DOCKET NO.: FCI-2598
Application No.: 09/208,962
Office Action Dated: October 8, 2004

REMARKS

Amendments to the Drawings

FIG. 14

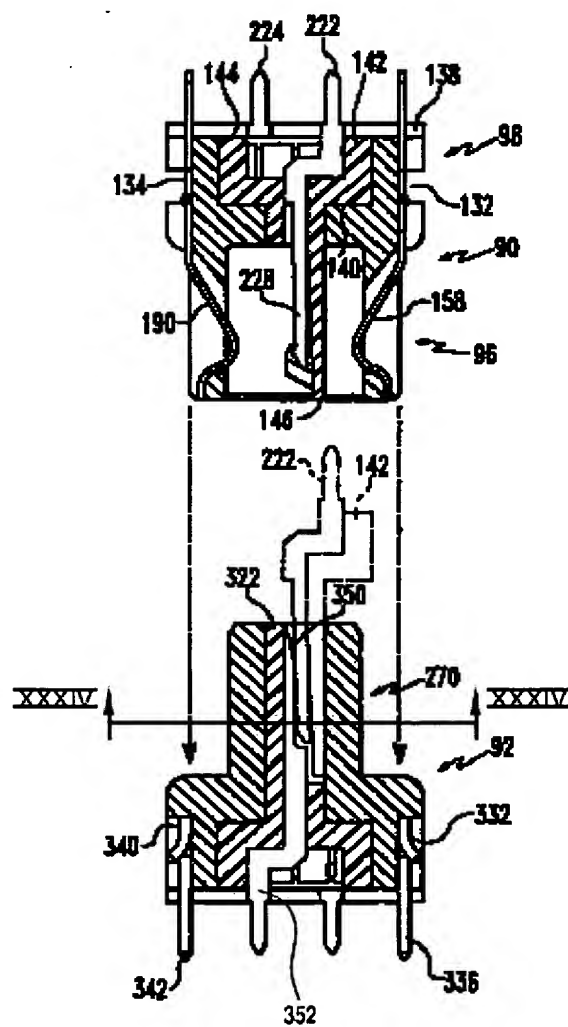
With respect to the amended Figs. 14 and 32, as further requested by the Examiner, annotated marked-up copies of Figs. 14 and 32 are provided on the next two pages of this response. Fig. 14 has been amended by adding the cross-section line XXXIV – XXXIV and by adding reference numeral 352 to more clearly indicate the signal contact in the receptacle. Fig. 32 has been amended by adding the cross-section line XXXV – XXXV and by adding new reference number 500 to more clearly indicate the signal contact in the receptacle. The amendments to each figure have been highlighted in yellow on the annotated marked-up copies.
